Intel Bay Trail-M Platform Block Diagram

Quanta Computer Inc. PROJECT : NL6		Rev 1A
Size	Document Number Valley 5/9 (SPI/GPIO/CLK)	
Date: Friday, April 25, 2014	Sheet 6 of 41

- 1. un-stuff R156 for SERIRQ skipped (Page14)
- 2. change power rail of Q35,Q36,Q37,Q44 from PP1800_PCH_S5 to PP1800_PCH for PP1800_PCH leakage issue in S3 mode (Page14)
- 3. unstuff R337 for S3 leakage issue(Page 11)
- 4. Delete LED2, R127 (Page 22,27)
- 5. Change LED1 type to right angle , same as 0C7 (Page22)
- 6. unstuff R454,Q33,Q144 for auto power on issue when insert battery first time(Page 26)
- 7. change PR130 to 124K ohm for efficiency improvement (Page 33)
- 8. change PL7/PL4 to 0.47uH and PR30/PR62 to 0ohm for efficiency improvement (Page 28)
- 9. unstuff NUT of Hole4,Hole5(Page 25)

Size Document Number Valley 7/9 (Power 1) Rev 1A
Date: Friday, April 25, 2014 Sheet 8 of 41

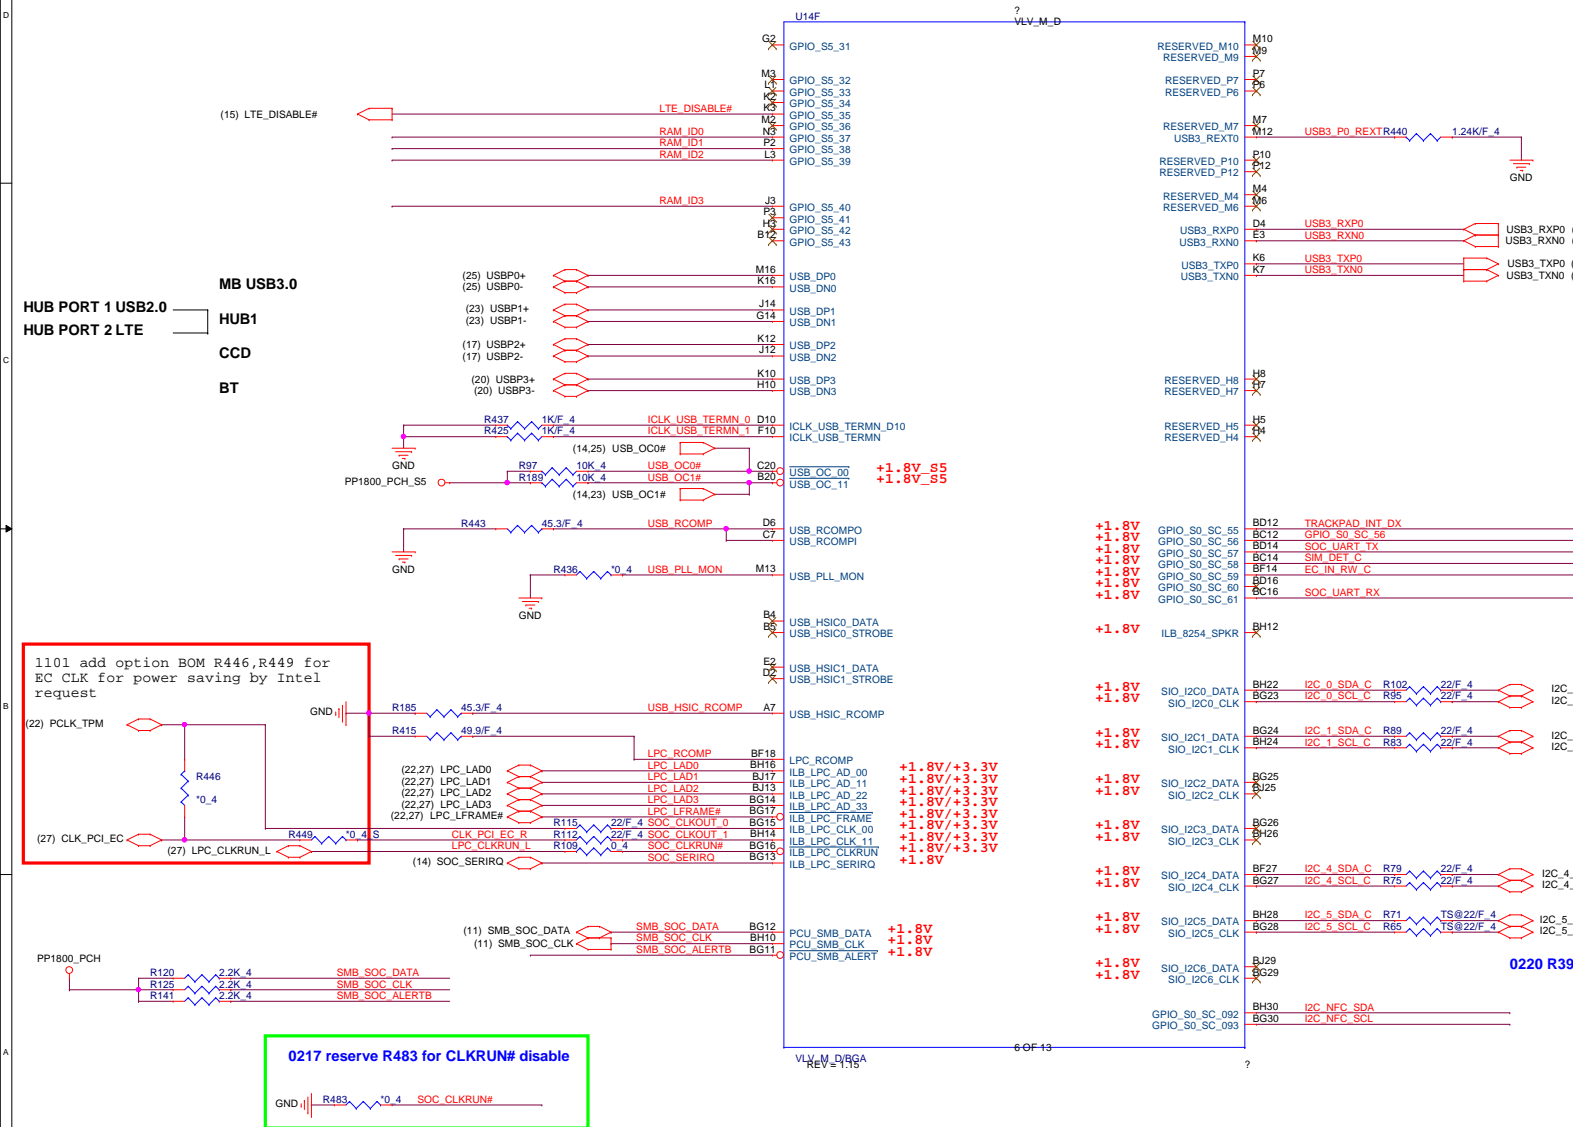
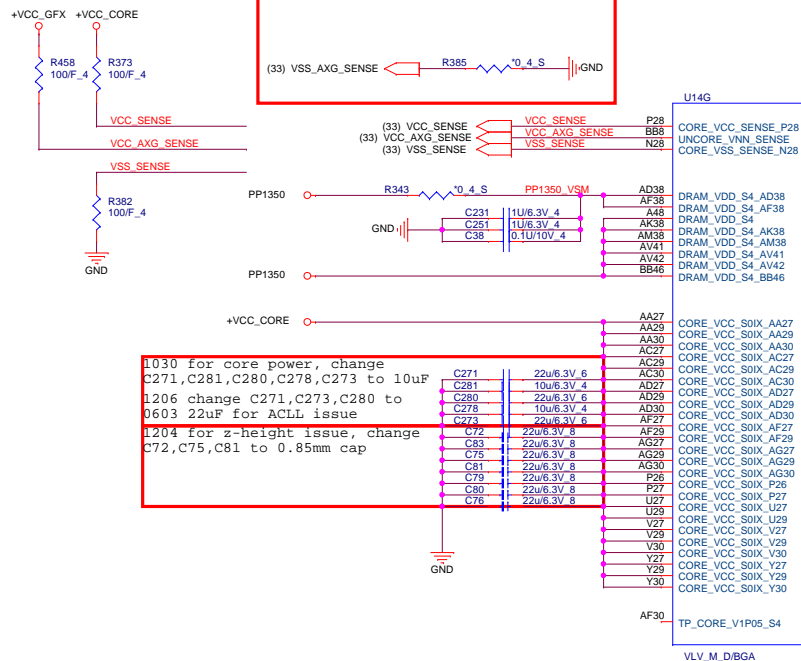
1031 for layout suggestion by intel, VSS_AXG_SENSE didn't connect to VSS_SENSE, will connect the GND via near VCC_AXG_SENSE
1031 for layout, add 0hm between GND and VSS_AXG_SENSE

1030 for core power, change C271,C281,C280,C278,C273 to 10uF
1206 change C271,C273,C280 to 0603 22uF for ACLL issue
1204 for z-height issue, change C72,C75,C81 to 0.85mm cap

1030 for Gfx power, change C266,C289,C290 to 10uF and add 2 caps 10uF
1206 change C266,C311,C315 to 0603 22uF for ACLL issue

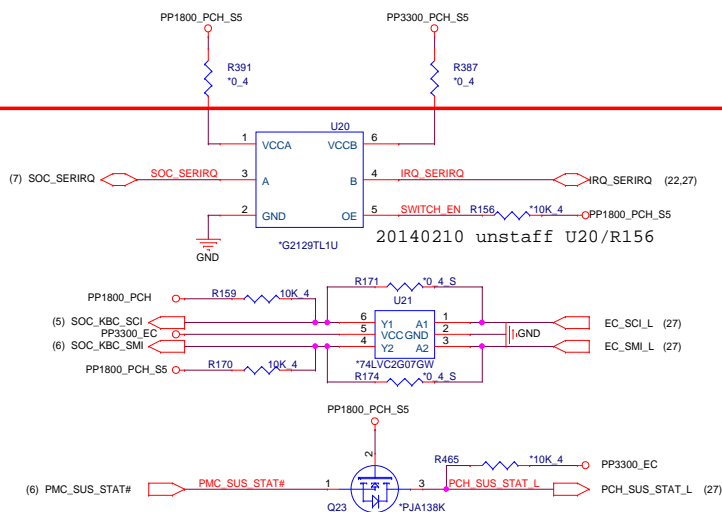
```
9/6 EC table says SERIRQ is OD pin, reserve for debugging
1128 remove R166, because SERIRQ of TPM needs 3V
1128 reserve 0 ohm R387/R391 on VCCA and VCCB for debugging
20140210 unstaff R387/R391
```

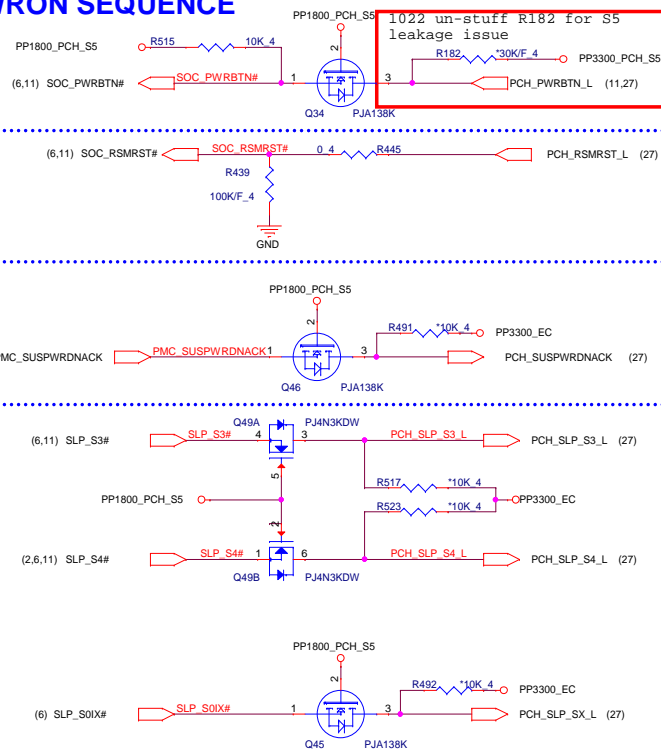
0128 change power rail of Q35,Q36,Q37,Q44 from PP1800_PCH_S5 to PP1800_PCH for PP1800_PCH leakage issue in S3 mode

SD/MMC CARD READER CONNECTOR (MMC)

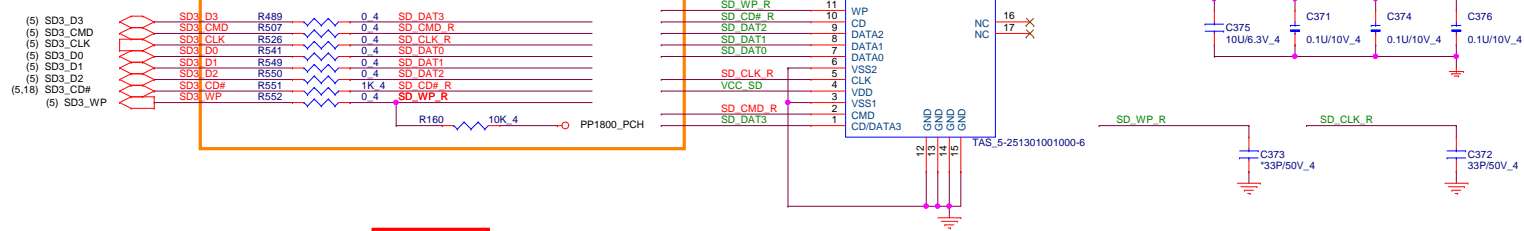
1205 the damping of SDIO change to 0 ohm by Intel request
 1205 add PU for SDIO WP by Intel request
 1205 R551 changes to 1K to isolate SD socket and servo/SoC
 1205 SD3_WP is 1.8V power rail in SoC, change external Pulled up power well of SD3_WP to 1.8V power

1211 add pulled up resistors on SDIO data/cmd lines
 1212 all pulled up resistors of SDIO data/cmd to be un-stuffed

HEADPHONE/Mic combo(ADO)

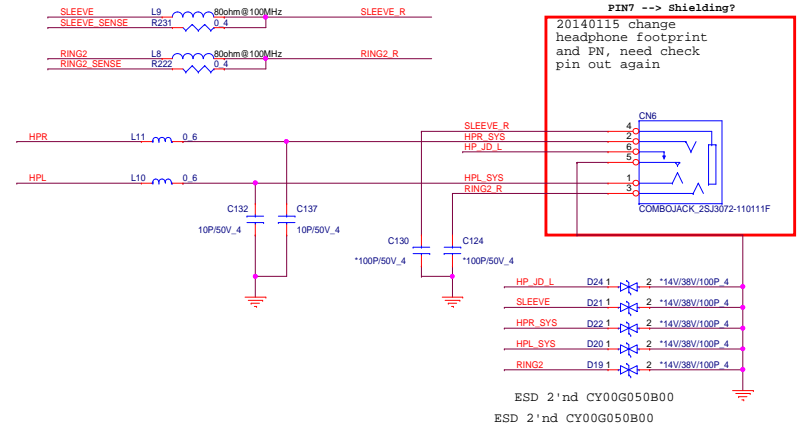
20140115 change
headphone footprint
and PH, need check
pin out again

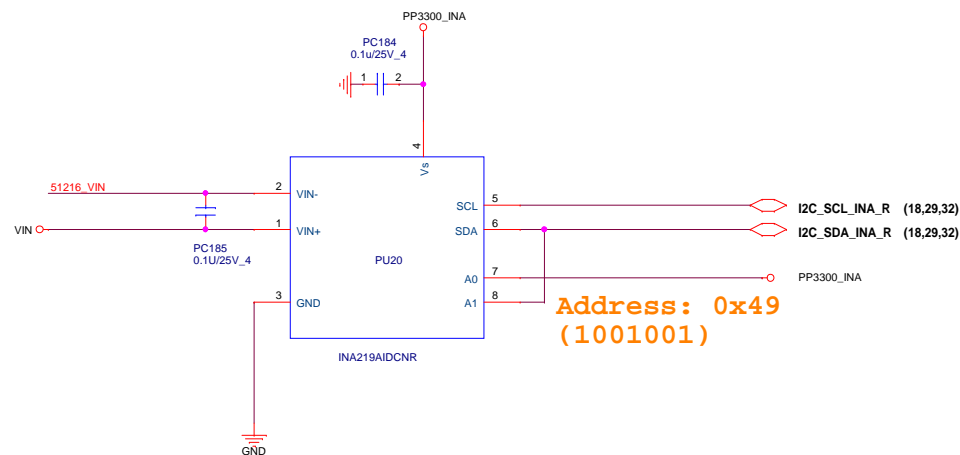
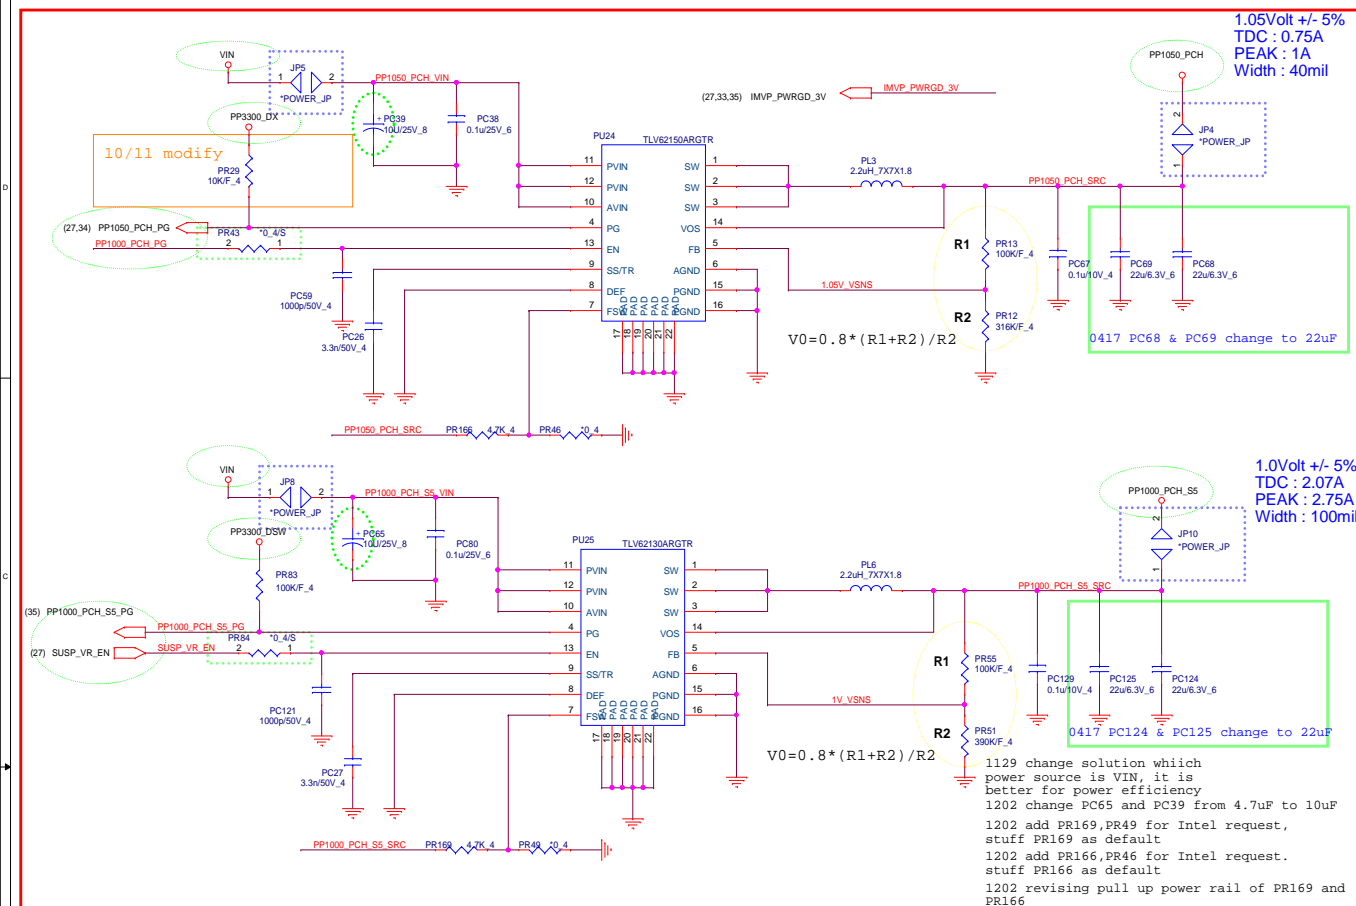
0417 PC13 change to 10uF ,
add 2x10uF PC215 , PC216

0417 PR21 change to 3.3ohm ,
PC32 change to 1200uF , PC29
change to 10uF

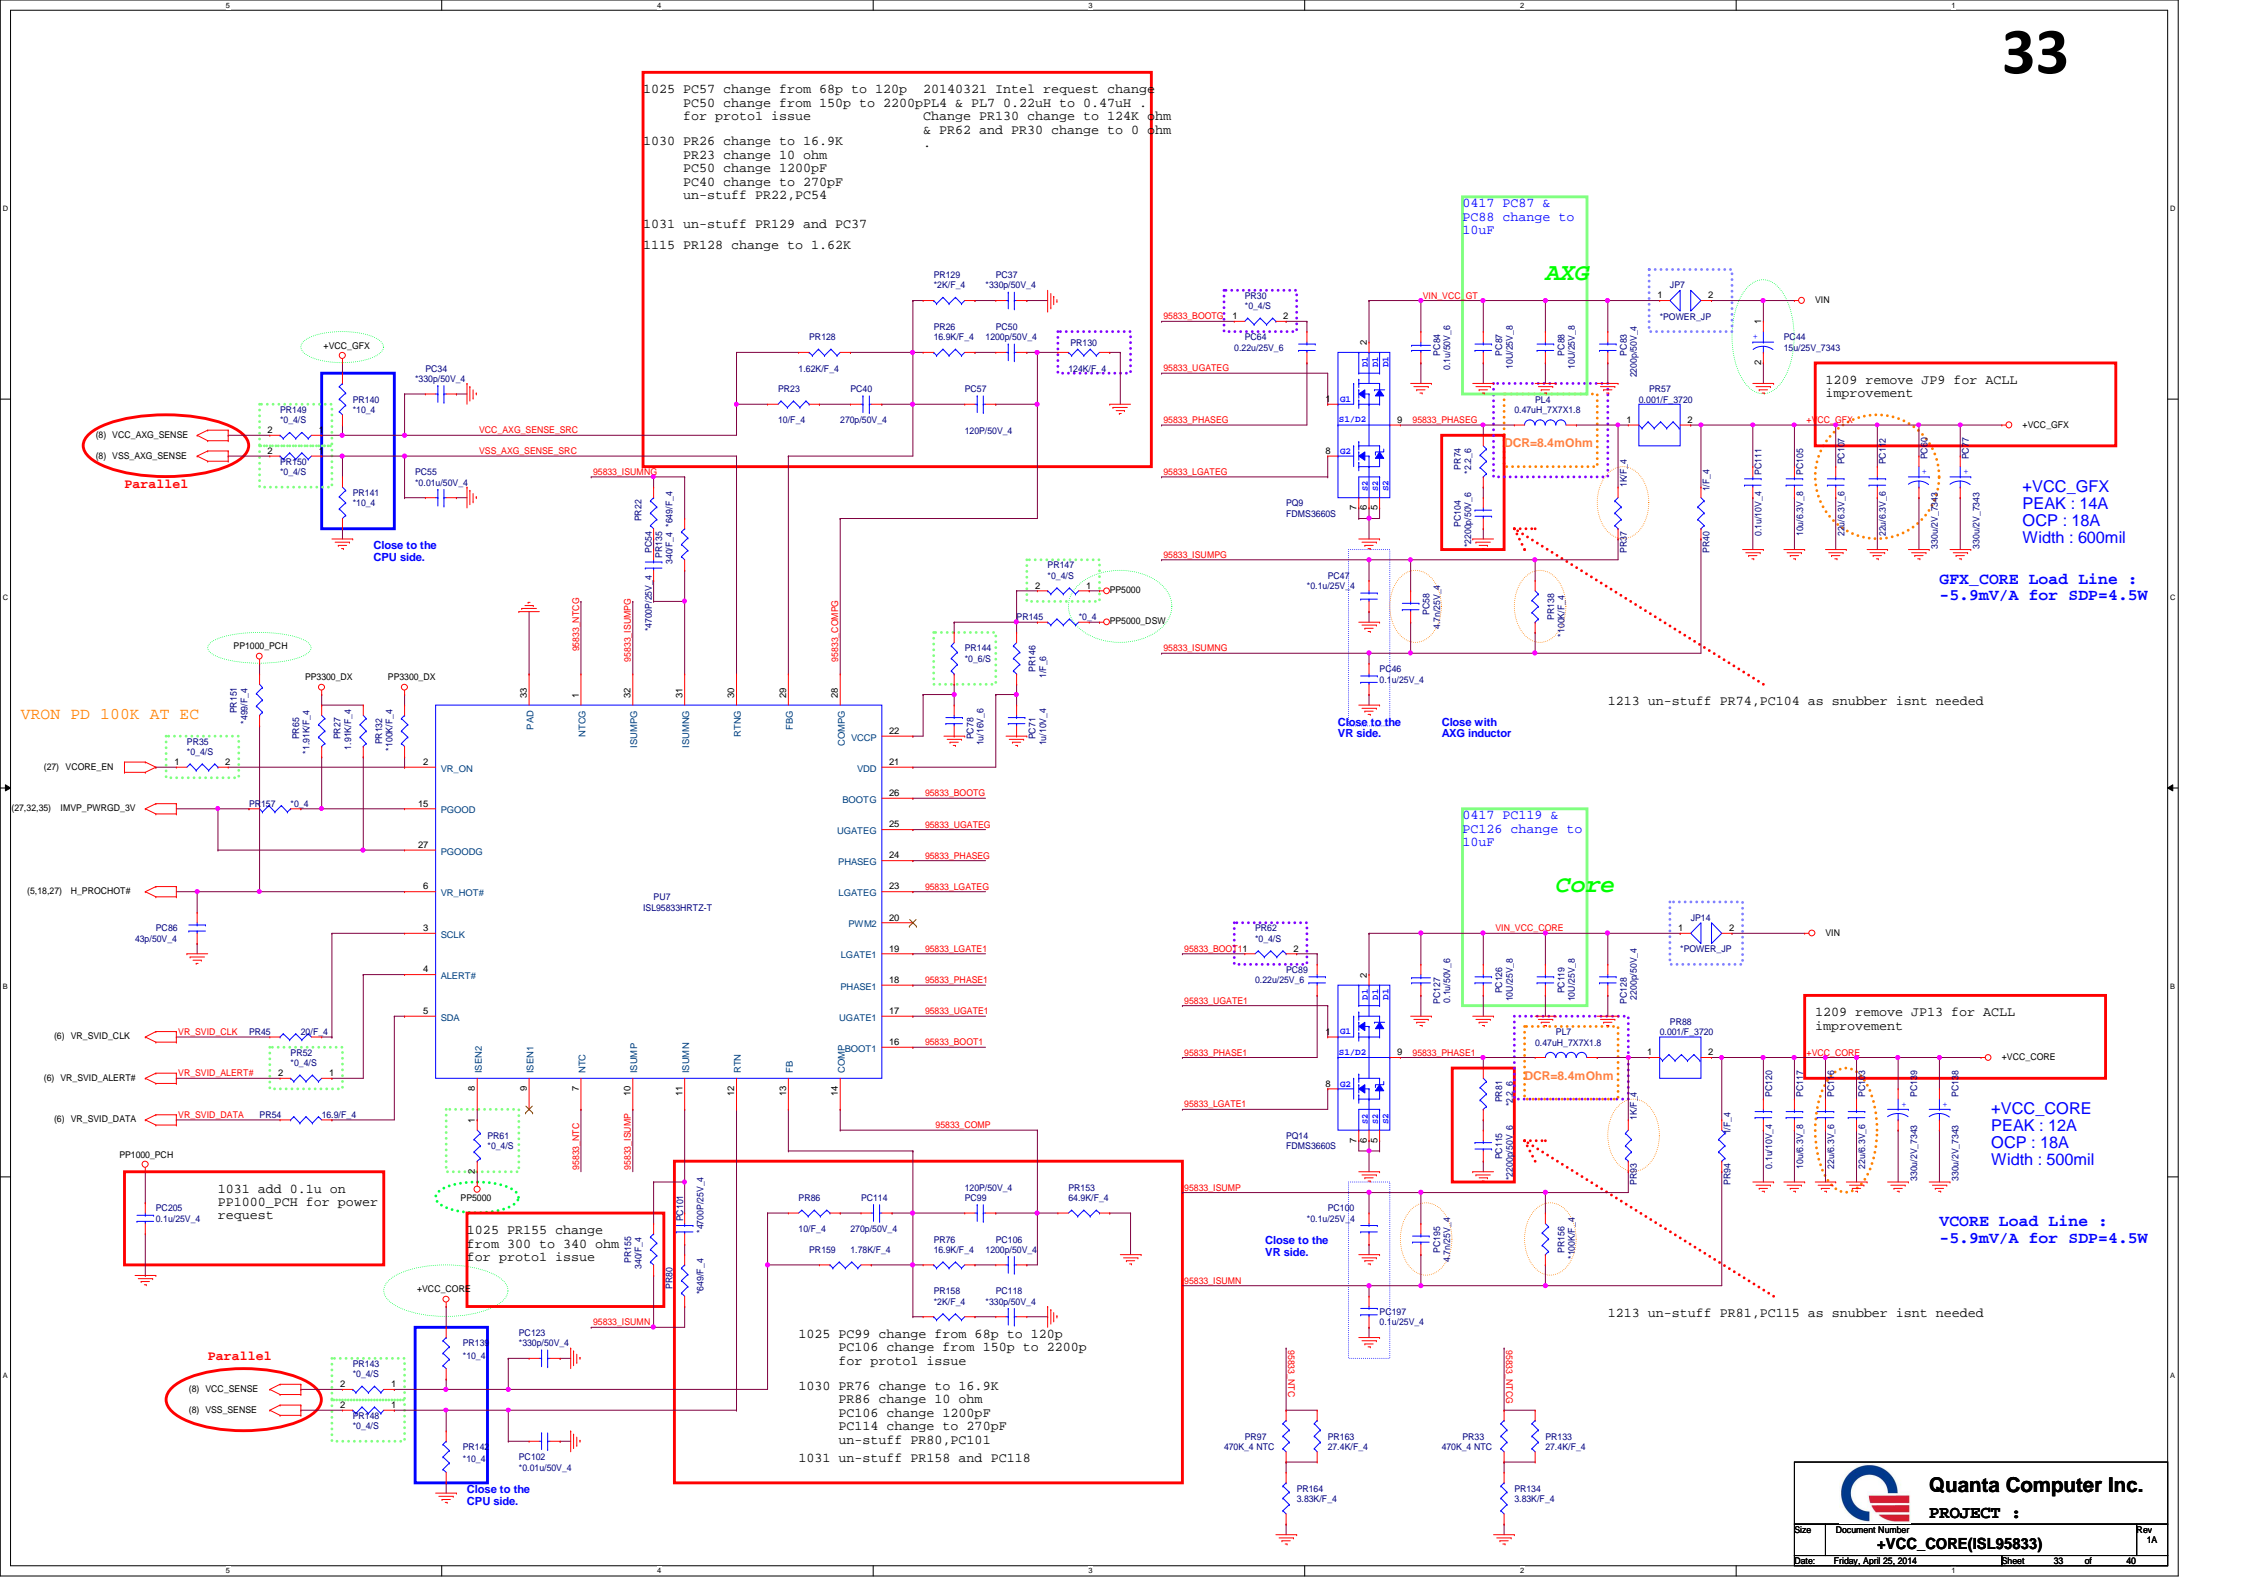
1129 because of power source of PU24, PU25 chagen to VIN, so that need change sensing power net

1129 PP1000_PCH changes from convert to power MOSFET type for power efficiency improvement

1025 PC99 change from 68p to 120p
PC106 change from 150p to 2200p
for protol issue

1030 PR76 change to 16.9K
PR86 change 10 ohm
PC106 change 1200pF
PC114 change to 270pF
un-stuff PR80, PC101

1031 un-stuff PR158 and PC118
